FINAL DRAINAGE REPORT

PPR 234

Schubert Ranch Sand Resource Pit

ELLICOTT SAND AND GRAVEL LLC - SITE DEVELOPMENT PLAN

STAGE I OF 6 - DRAINAGE PLAN

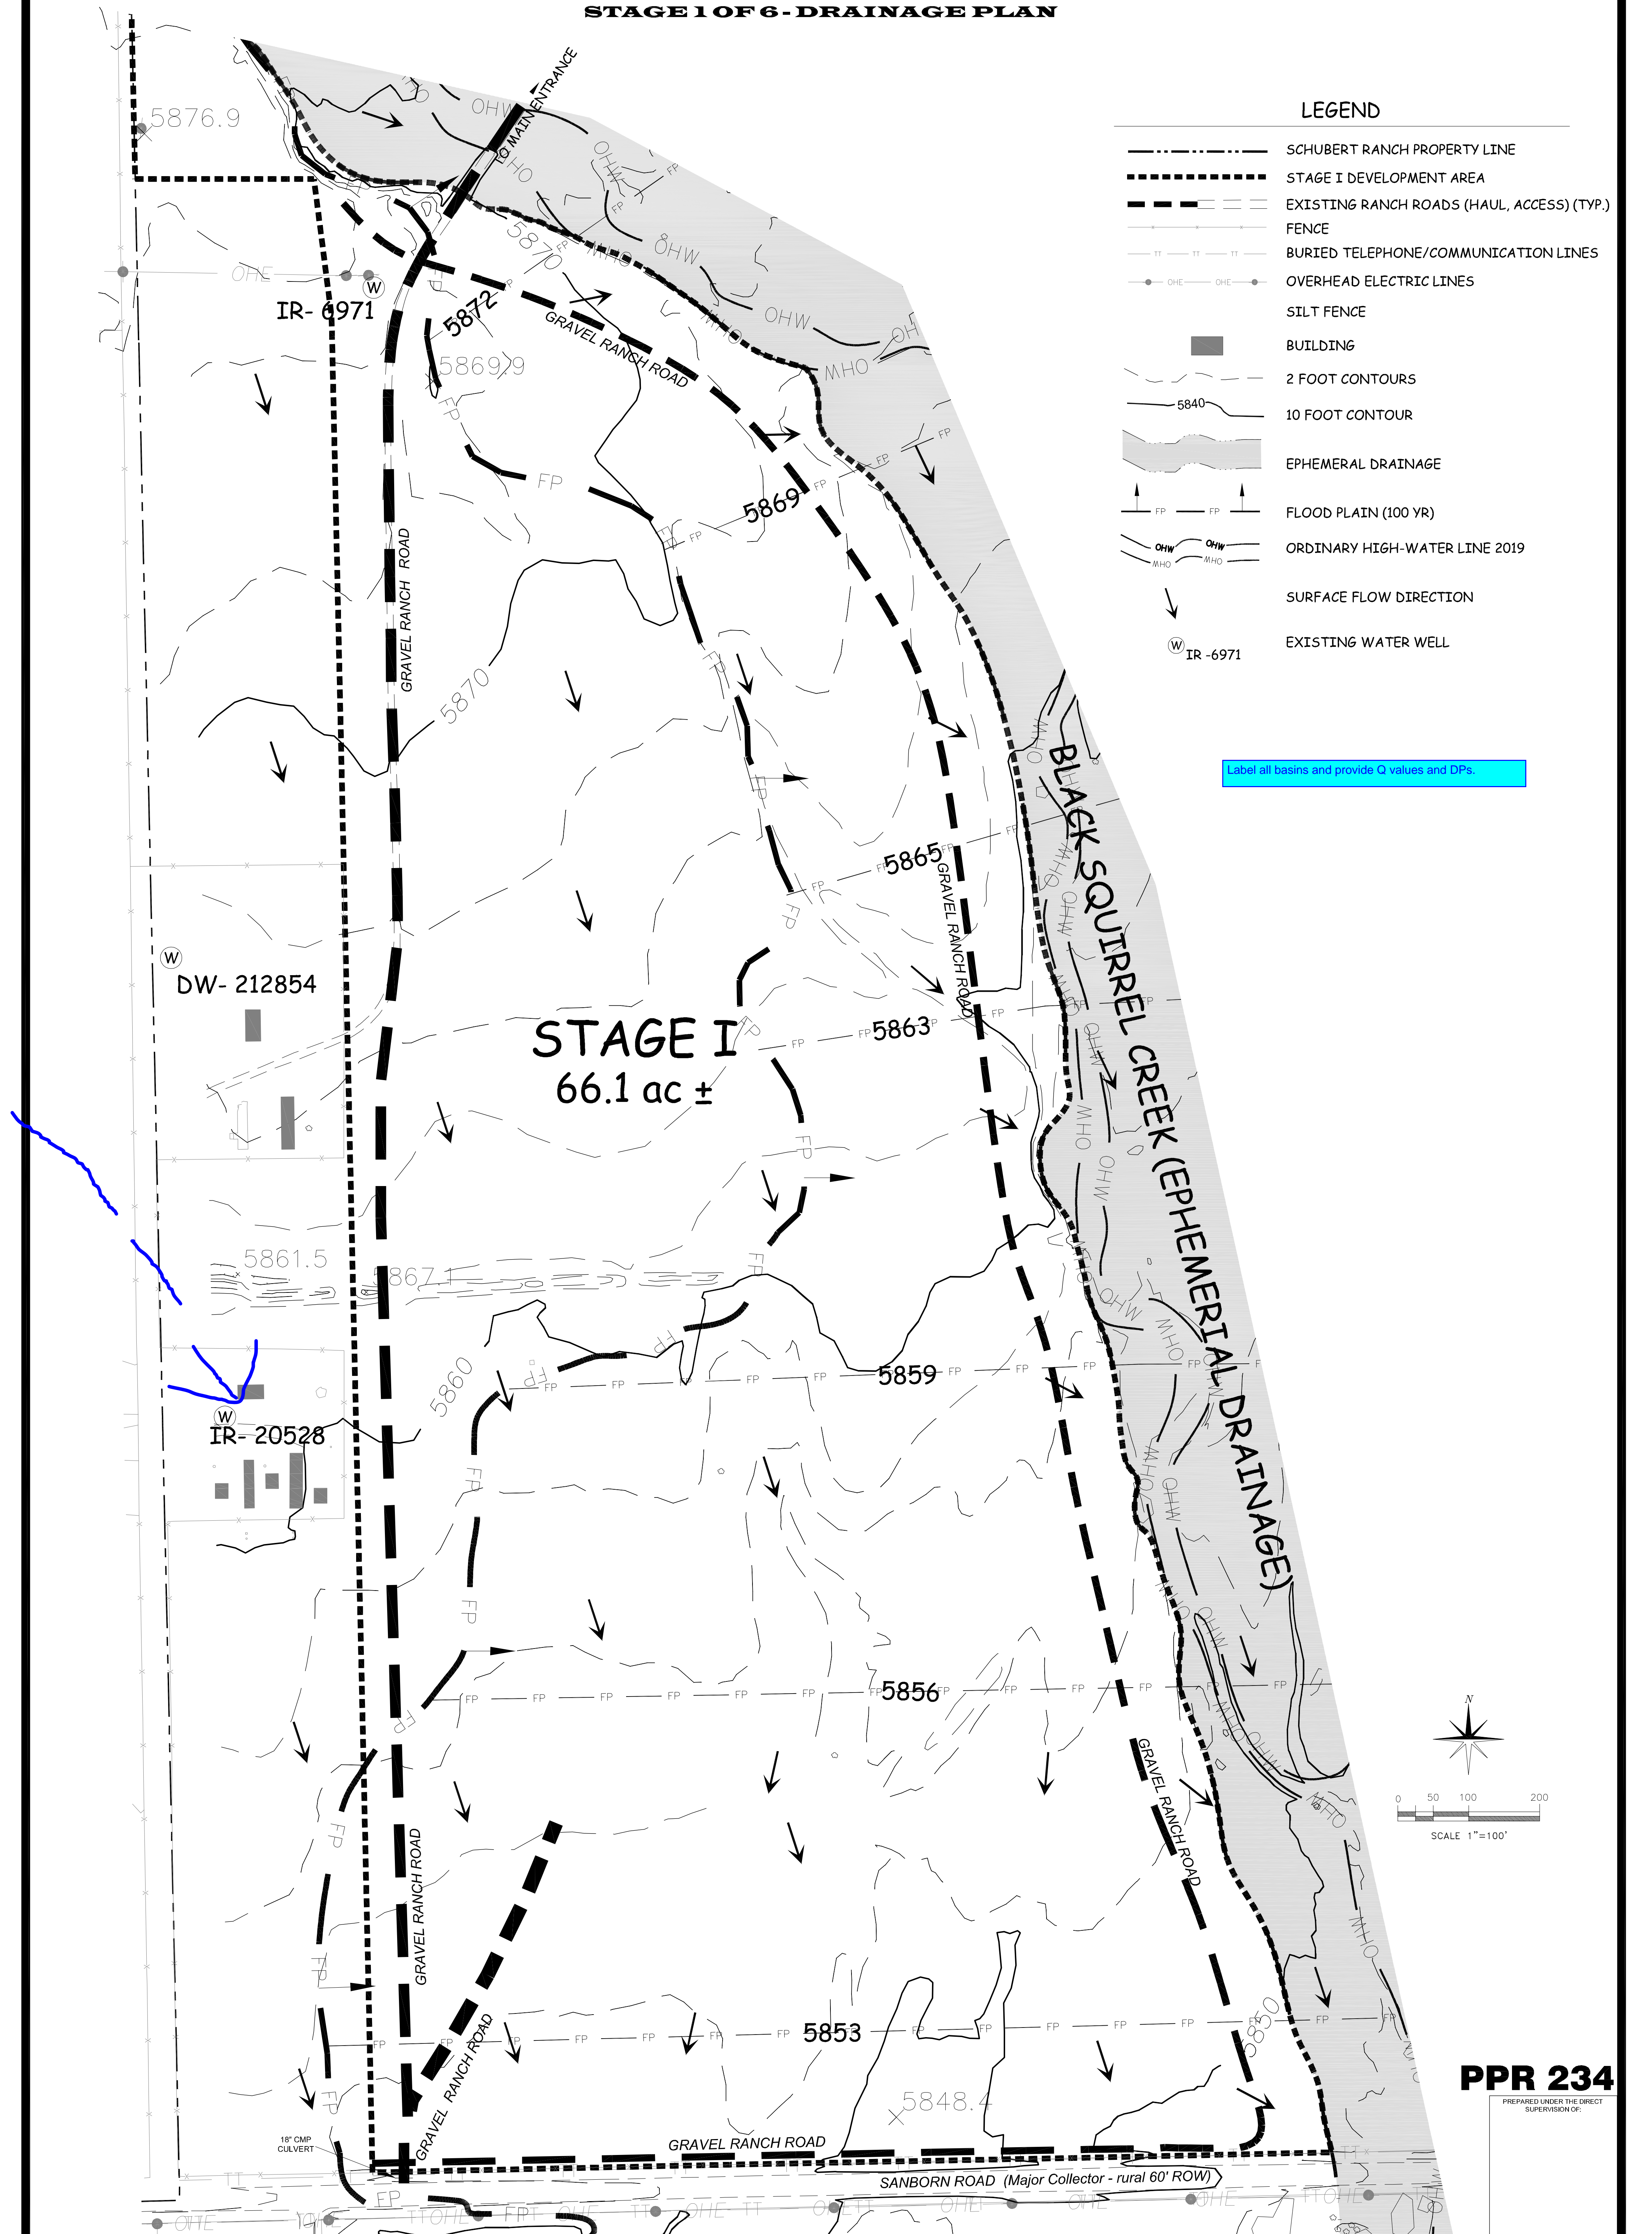
Label all basins and provide Q values and DPs.

EL PASO COUNTY DEVELOPMENT PLAN
FINAL PHASE
FOR
SCHUBERT RANCH SAND RESOURCE
EL LICOTT, COLORADO

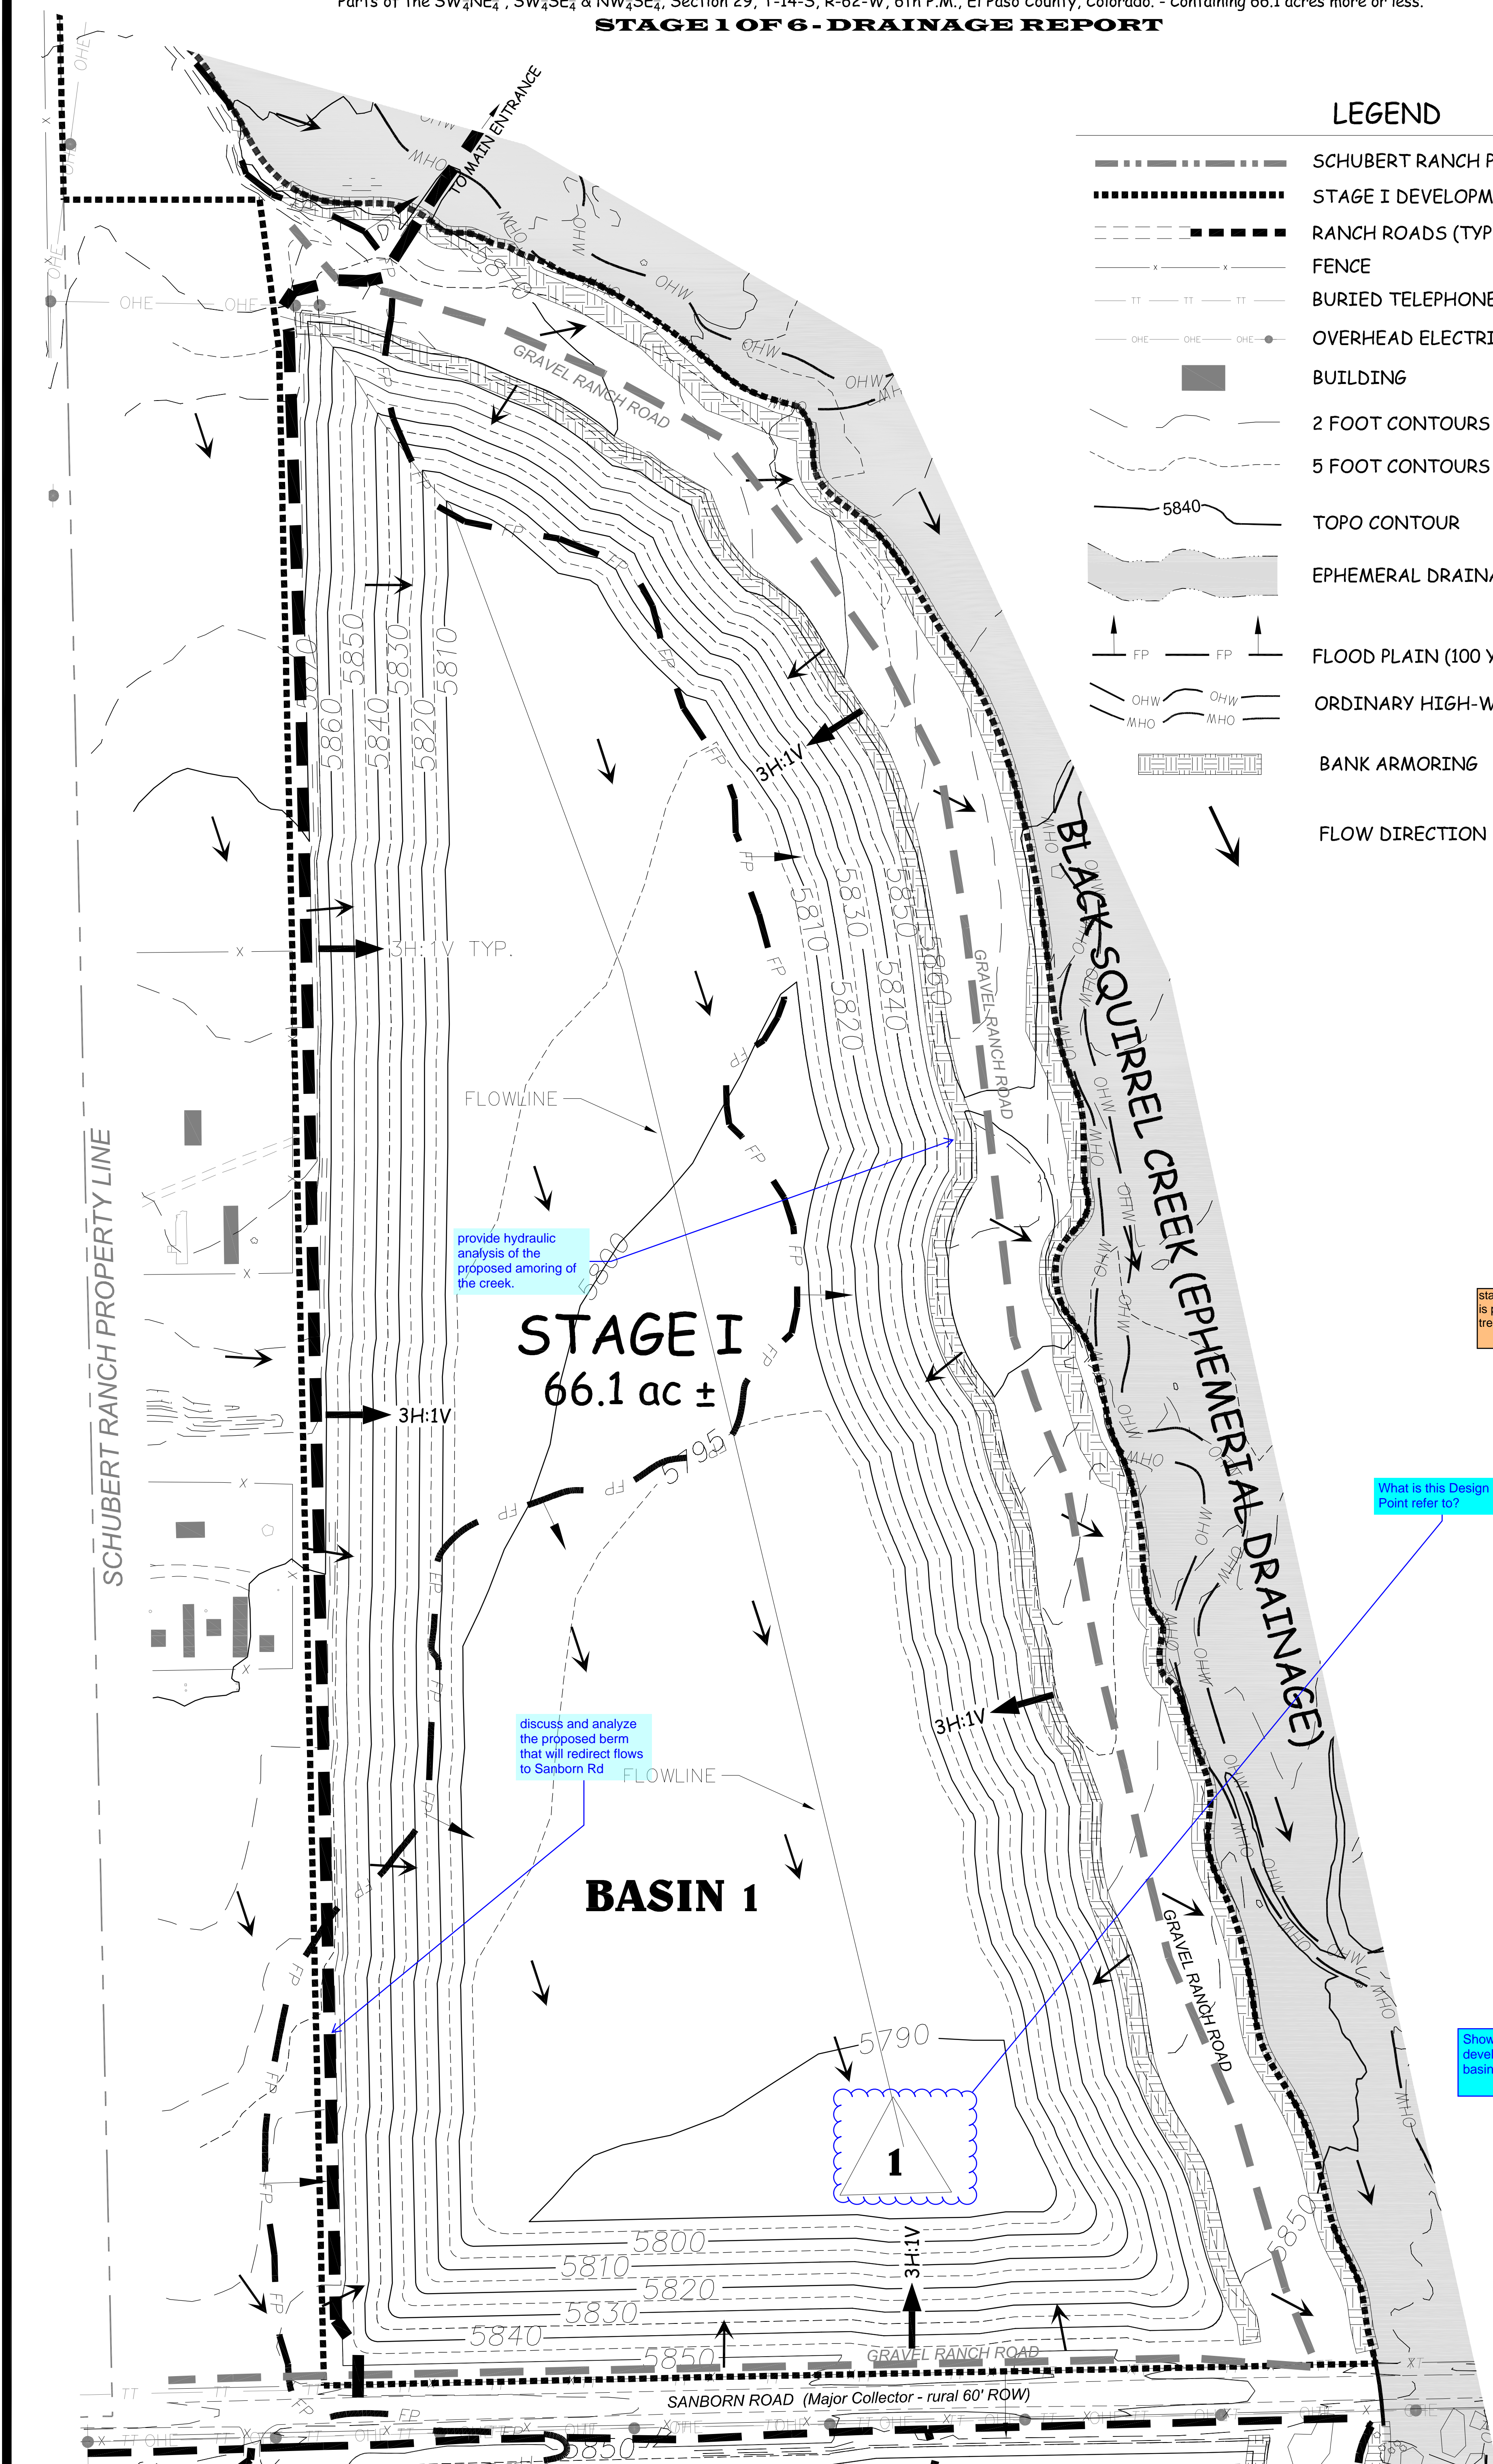
provide hydraulic analysis of the proposed armoring of the creek.

What is this Design Point refer to?

state in report text above how WQ treatment is provided for each basin or which WQ treatment exclusion is applicable.

Show flows and design points for developed conditions in and out of the basins.

FEMA Flood Insurance Rate Map (FIRM):

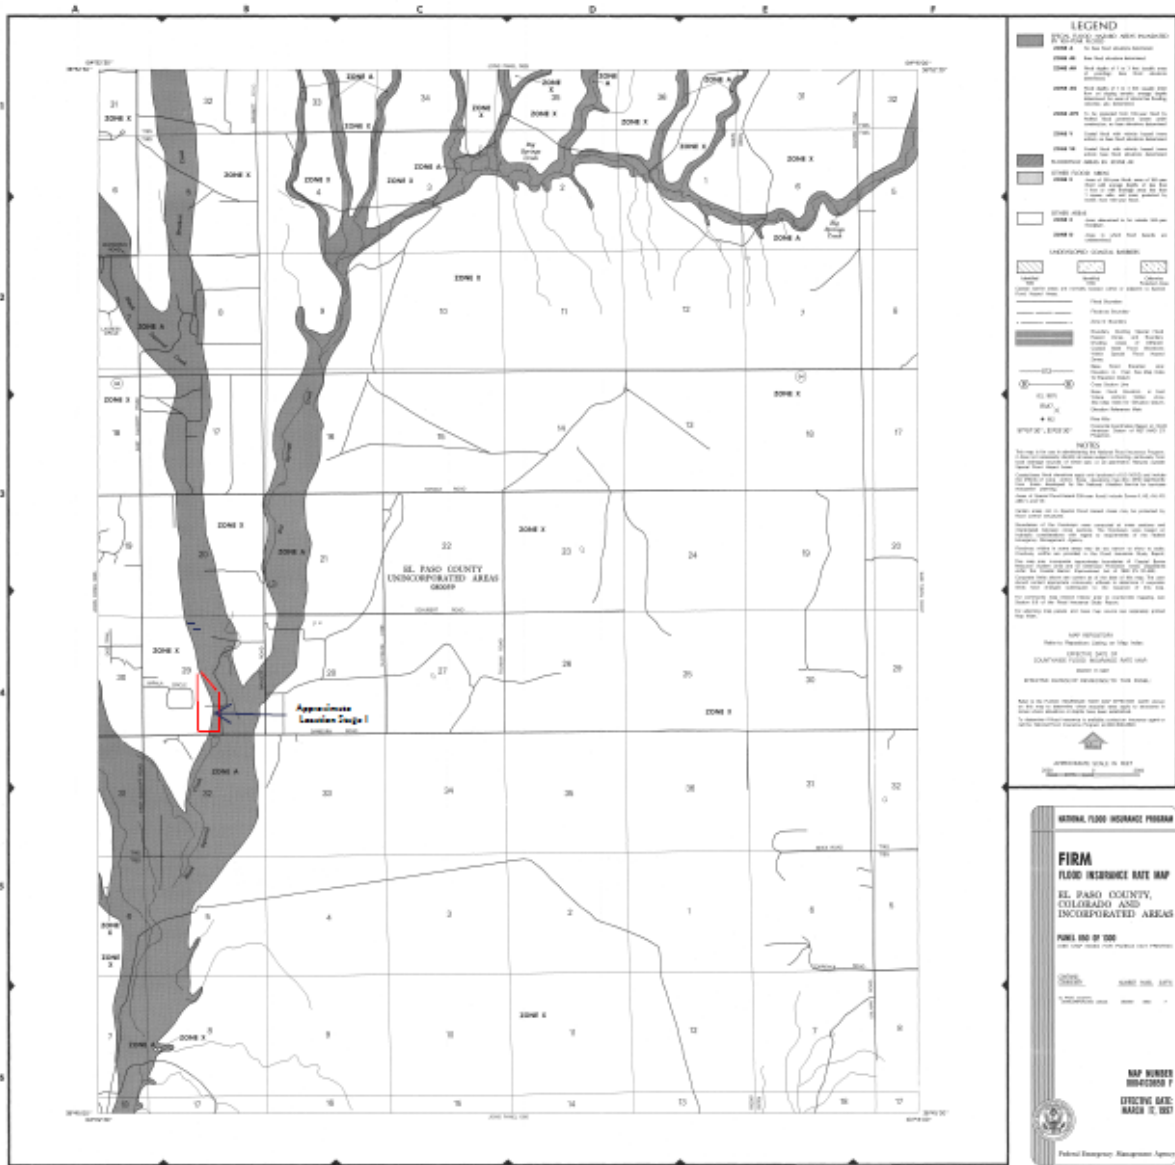
Please include the FIRM flood map # 08041C0840G & 08041C0830G, effective on 12/7/2018 and include the flood zone designation type Zone AE.
